# Public Comments Report: Formal Actions on all Public Comments and Committee Comments

October 1, 2019

**Figure 613.6** Coefficient  $I_e$  relative to geographic location

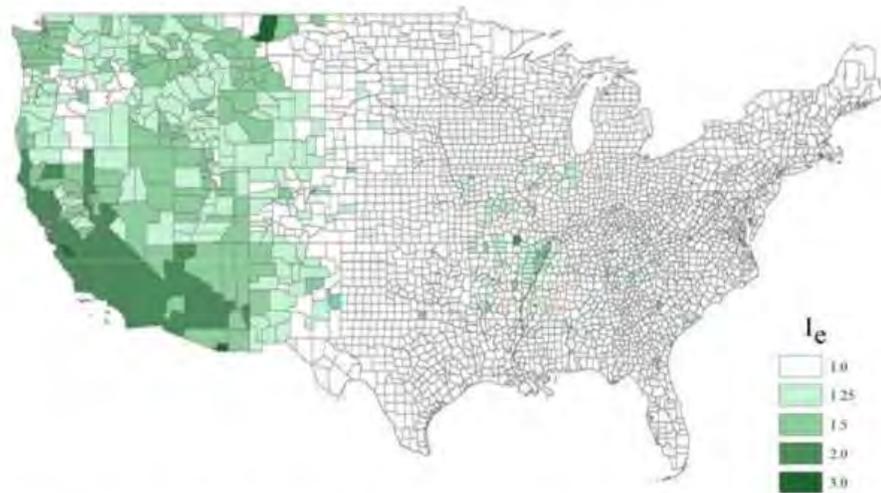
**Figure 2-12.** Maximum strength and stiffness factor  $I_e$  to exceed 2015 IBC and IRC seismic design requirements where the incremental benefit remains cost-effective.
